STATE OF DELAWARE  
EXECUTIVE DEPARTMENT  
OFFICE OF MANAGEMENT AND BUDGET  
STATE PLANNING COORDINATION

RE: PLUS 2008-05-02; Wandendale Regional Water Recharge Facility

# Wandendale Regional Water Recharge Facility

**Wandendale Regional Water Recharge Facility (PLUS 2008-05-02)**

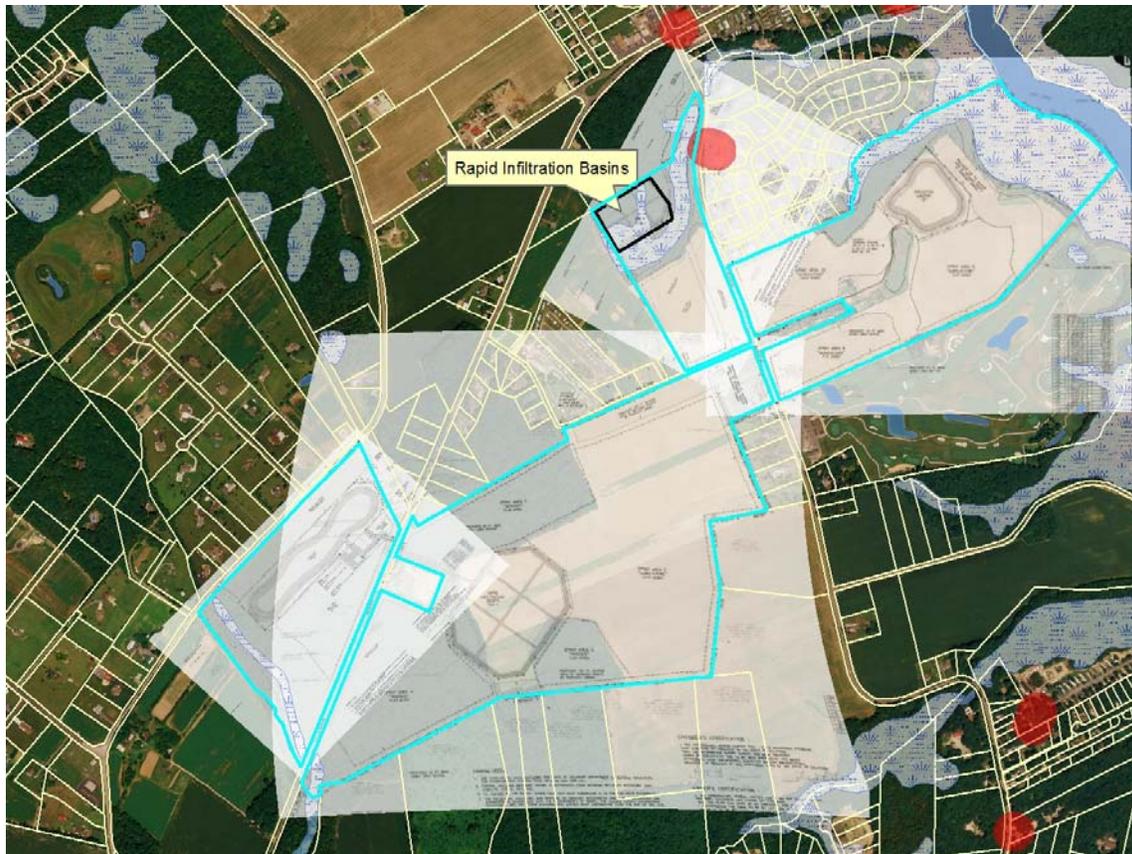
The Ground-Water Protection Branch (GPB) has determined that the project falls within a wellhead protection area for Tidewater Utilities (TWU) Love Woods, PWSID 00A0329 (see following map and attached map). Wellhead protection areas are surface and subsurface areas surrounding a public water supply well where the quantity and quality of ground water moving toward these wells may be adversely affected by land use activities.

The site plan submitted by the Developer show Rapid Infiltration Basins (RIBs) Area B in the northwest corner of tax map parcel 234-7.00-127.00. According to the Delaware Geological Survey ground water elevation GIS overlays, this RIB system is approximately 360 feet up-gradient of the TWU wells (see map). As cited, this RIB system is a potential source of contamination if there is a failure in the system that may cause the TWU Public Drinking Water System to exceed drinking water standards.

In addition, according to the 2002 Land Use GIS overlay, the RIB system is cited in a wetland. By design, RIB systems infiltrate water into the soil profile at a rapid rate. Wetlands do not allow for the designed purpose.

- 1) Move Rapid Infiltration Basins (RIB) Area B to another location outside the wetland and down or side-gradient of the TWU wells.
